Application for Amendment

Which permit do you wish to amend? (List permit number and issuing agency.)	<u>Approval 10004.</u>
Legal Land Description(s)	<u>SE 27-36-28 W 4.</u> (Qtr-Sec-Twp-Rg-W Mer)

We like to change The permit for the lagoons from a two cell to a one cell with final dimensions of 80 x 80 x 4.8 meters no changes to total depth or approved liner.

**Re: Meilink Dairies Ltd. – Inspection and Amendment
Approval No. RA10004
SE 27-036-28 W4M
Red Deer County, Alberta**

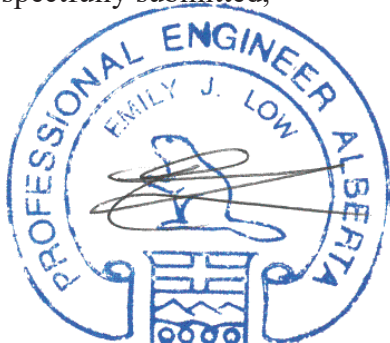
The EMS was found to be 80 meters by 80 meters. The depth of the EMS could not be measured at the time of the inspection due to manure being present in the lagoon. Confirmation from the operator and construction contractor indicated that the overall depth was approximately 4.8 meters below top of bank. The dyke walls are from 0.5 to 1.0 meters above grade with an exterior slope at a minimum 4:1. The inside wall slope is approximately 3:1. The depth to groundwater was determined to be more than 1 meter below the depth of the liner prior to construction.

The dimensions differ from the permitted construction dimensions. The current capacity is 17,906 cubic meters, the required capacity as calculated by Envirowest (2010) is 17,540 cubic meters. The amendment of the lagoon from a two cell storage system to a one stage storage system at the measured dimensions provides sufficient storage capacity.

The lagoon was constructed in the same area as indicated in the submitted site plan. A compacted clay liner was installed in the side walls and floor of the EMS. The liner depth was verified to be at least 1.0 meter thick and up to 3.0 meters. The liner material used was that tested as part of the original site assessment.

Compaction testing of the liner was undertaken for the EMS at four locations. Results of the testing are detailed below.

Based on the information collected it is considered that the installed liner meets the applicable requirements as outlined in the Envirowest Engineering report.

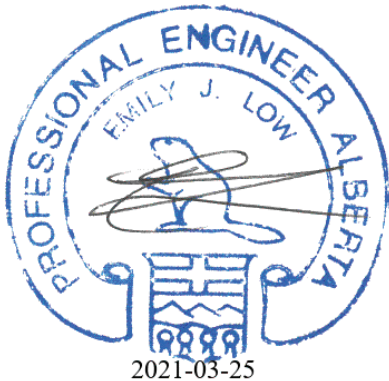
The EMS was found to be 80 meters by 80 meters. The depth of the EMS could not be measured at the time of the inspection due to manure being present in the lagoon. Confirmation from the operator and construction contractor indicated that the overall depth was approximately 4.8 meters below top of bank. The inside wall slope is approximately 3:1. The dimensions differ from the permitted construction dimensions. The current capacity is 17,906 cubic meters, the required capacity as calculated by Envirowest (2010) is 17,540 cubic meters. The amendment of the lagoon from a two cell storage system to a one stage storage system at the measured dimensions provides sufficient storage capacity.

The lagoon was constructed in the same area as indicated in the submitted site plan.
